E4980A-01B

S E R V I C E N O T E

E4980A Precision LC Meter 20 Hz to 2 MHz

Power supply for E4980A might be defective due to its design

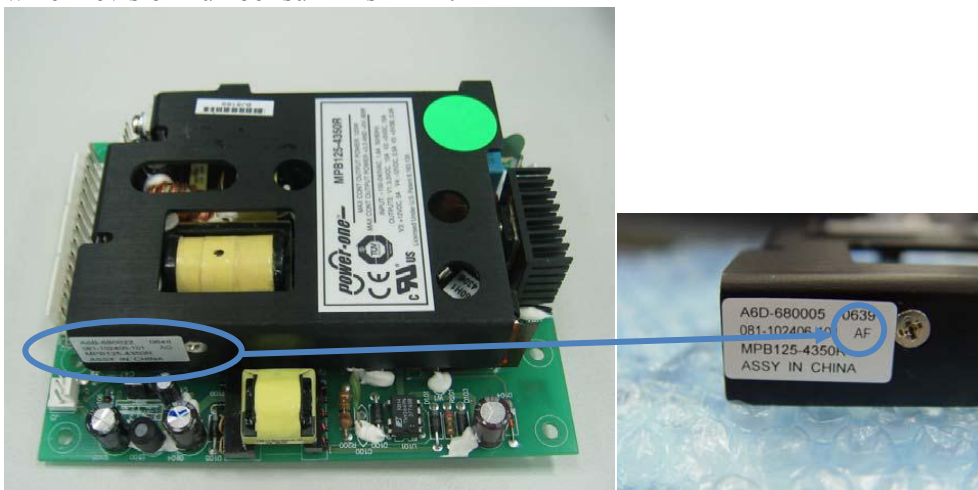
The E4980A specified above serial numbers contain the power supply that might be defective due to a problem in its design by a third company.

For MY46100102 to MY46100134, the power supply has the sticker on which “OLD PS” is written as shown in the figure below.

For MY46100889 to MY46101187 and SG46100109, the power supply has the MPN sticker with which revision number suffix is “AF”.

Replace the old power supply with the new one (p/n 0950-5146).

Use the new base plate (p/n E4980-00111) and the new power cable Assembly (p/n E4980-61601) for the new power supply.
